Axiom Hub

Version: V1.0.6

Release Note

(2020-07-07)

2) Add Audible Tamper Alarm Function

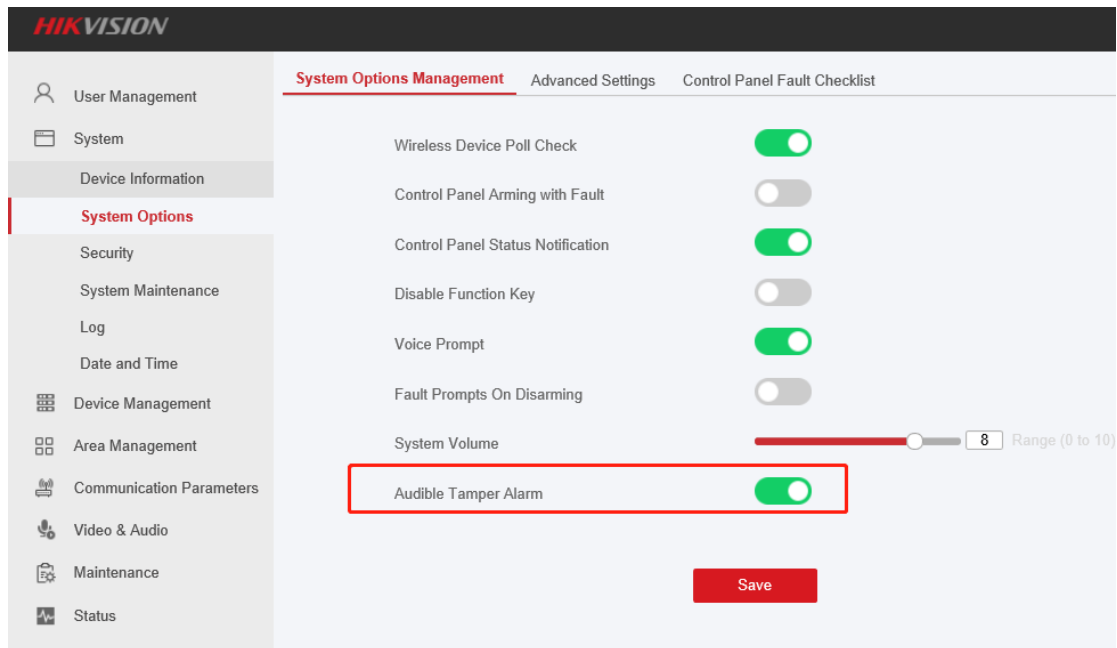
If the option is enabled, when any device triggers a tamper alarm, it will link the siren and the control panel alarm. (Enabled default)

If the option is disabled, when any device triggers the tamper alarm, only the log is uploaded.

3) Add Zone Double Knock Function:

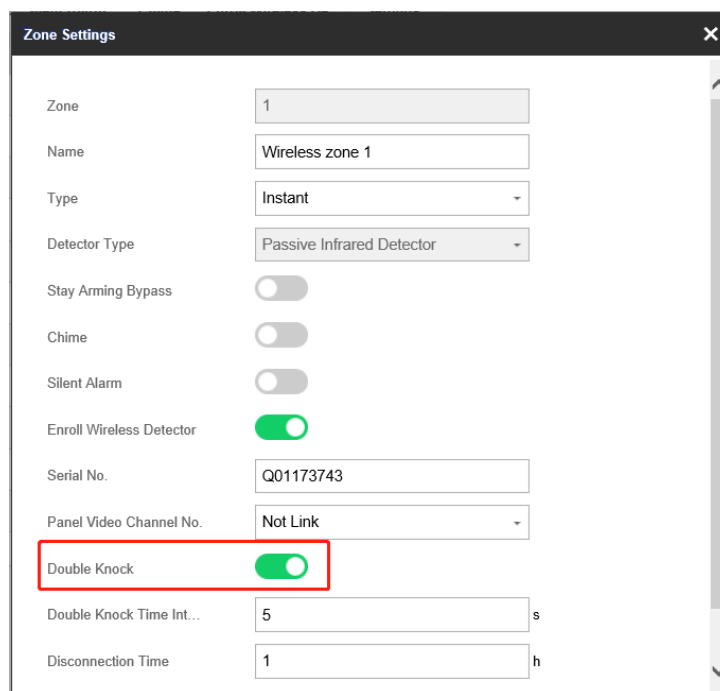
Double Knock Function: One Detector need triggered two times or continuous triggered, then it will trigger the Panel alarm

4) Add Key Switch zone trigger type.

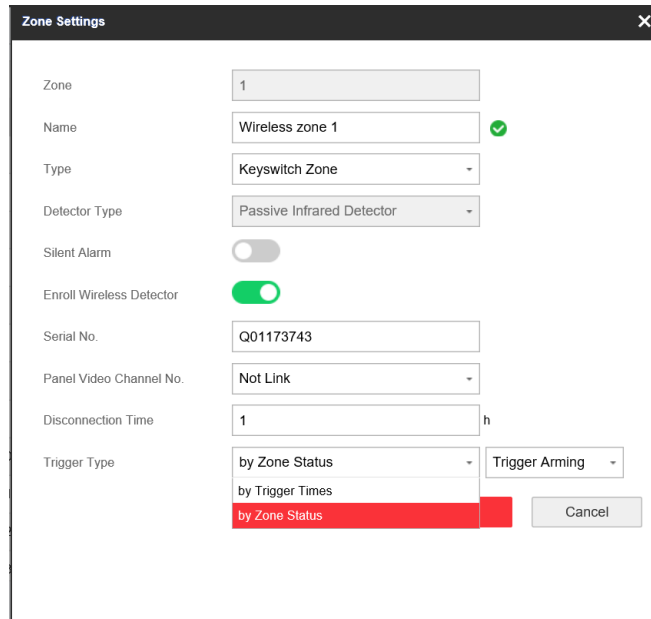
Add the key zone trigger type---By Trigger Time

By trigger Times: First time triggered will arm the Partition, second time triggered will disarm the partition.

By Zone Status: The linked area will arm after being triggered, and disarm after being restored.

5) Add Keyfob and Keypad Panic Silence alarm:

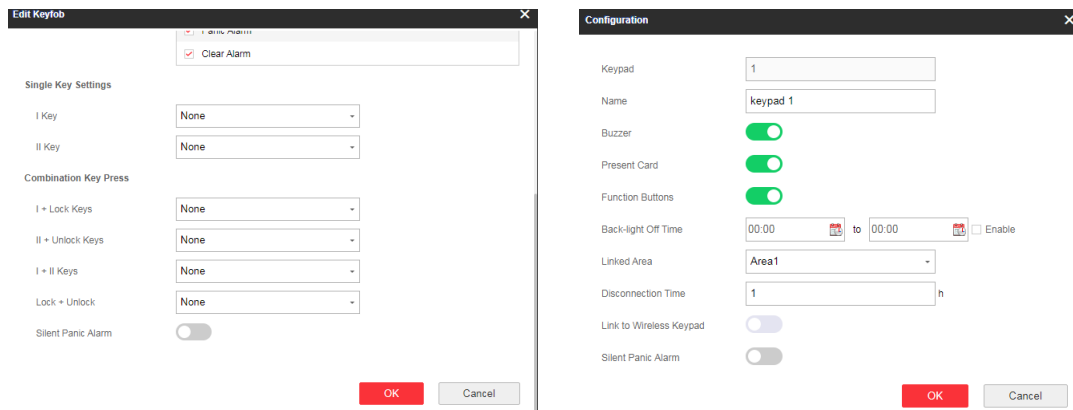
Add Keyfob and keypad options, can choose link sound or silence of the Panic Alarm.

6) Add Wireless Keypad Operation Voice Prompt:

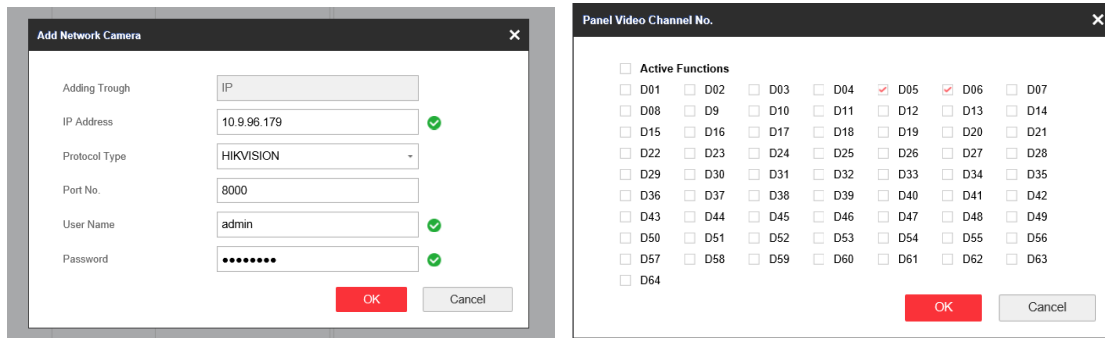
Add Wireless Keypad Operation Voice Prompt when device wake up, this can help customer know wireless keypad wake up success or not.

(DS-PKA-WLM Wireless Keypad need upgrade to newest version by serial cable)

2) Relay Linkage Optimization

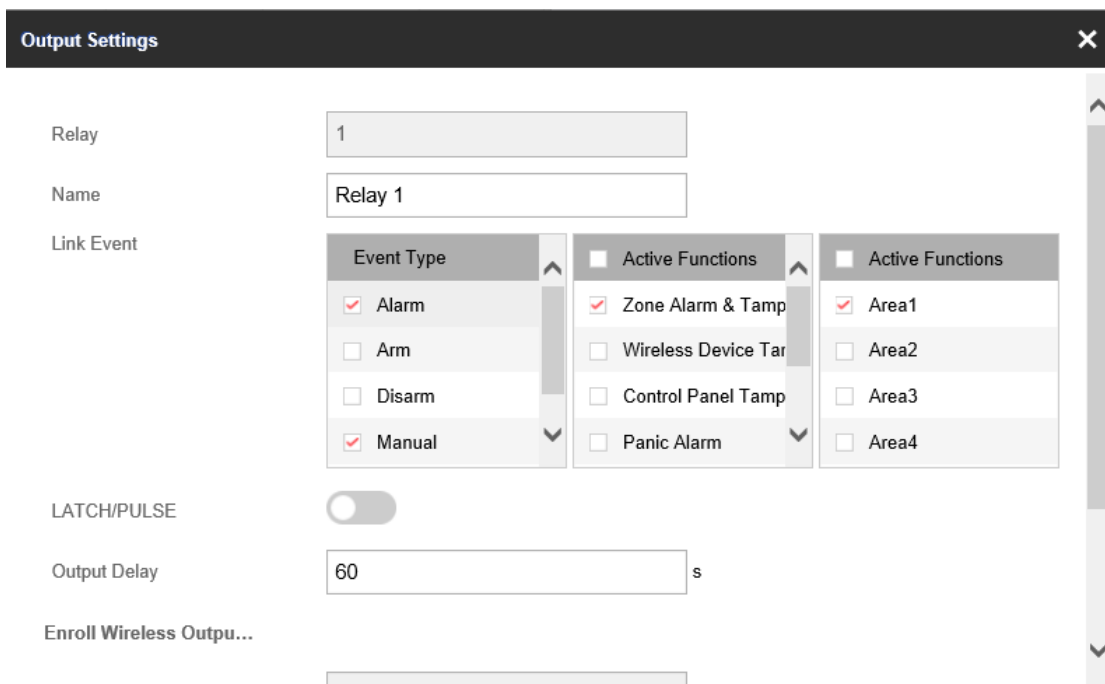
Support multi-selection of linkage events. .

3) Siren Linkage Optimization

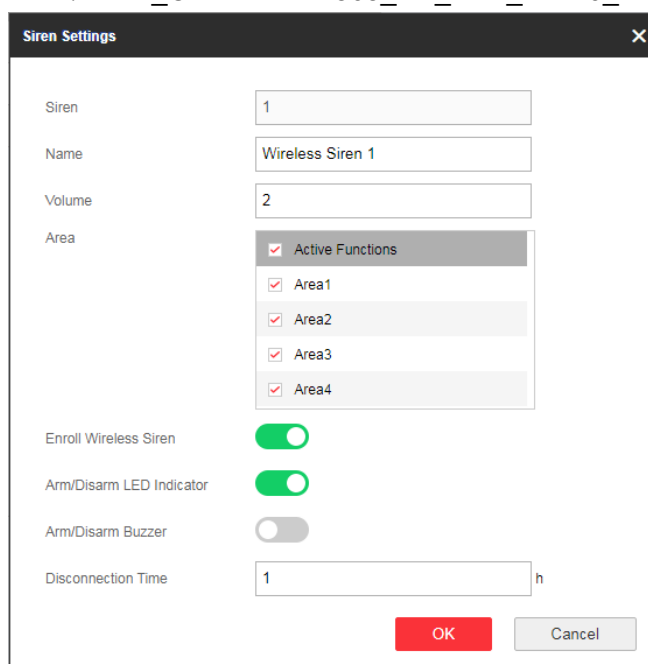
Support multi-selection of linkage events. You can enable or disable Arm/Disarm LED indicator and buzzer.

Arm/Disarm LED indicator: when arm the system success, the siren LED will flash one time; Disarm success, the LED will flash two times.

Arm/Disarm Buzzer: when arm the system success, the siren buzzer will ring one time; Disarm success, the LED will ring two times.

(DS-PSG-WI and DS-PSG-WO Wireless Siren need upgrade to newest version by serial cable)
